# Access Compliance Report

## Public Rights-of-Way

### (Pedestrian Signals)

Intersection ID: N/A	Main Street:	Cross Street: N/A	Location: N/A
ADA ID: C5721F099274	Signal Type: Two Push Buttons-Non APS	Overall Compliance: No	Severity Score: BTN 1:N/A BTN 2: N/A No BTN: N/A
Codes/Mitigation Info/Possible Solution		Field Measurements/Component Compliance

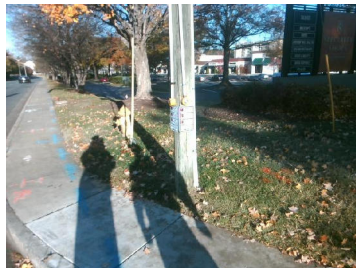
Yes	B 1 Clear Xing Direction?	ClearlyMarked	Yes	B 2 Clear Xing Direction?	ClearlyMarked
	B 1 Crossing Direction	To SW		B 2 Crossing Direction	To SE
No	B 1 DistanceTo XWalk (in)	74.0	Yes	B 2 DistanceTo XWalk (in)	0.0
Yes	B 1 DistanceTo Curb (in)	66.0	Yes	B 2 DistanceTo Curb (in)	67.0
Yes	B 1 Diameter (in)	2.0	No	B 2 Diameter (in)	2.0

Possible Solutions: Replace Signal Push Button With APS Button on New Post. Remove & Relocate Sign. Adjust Signal Button Height.
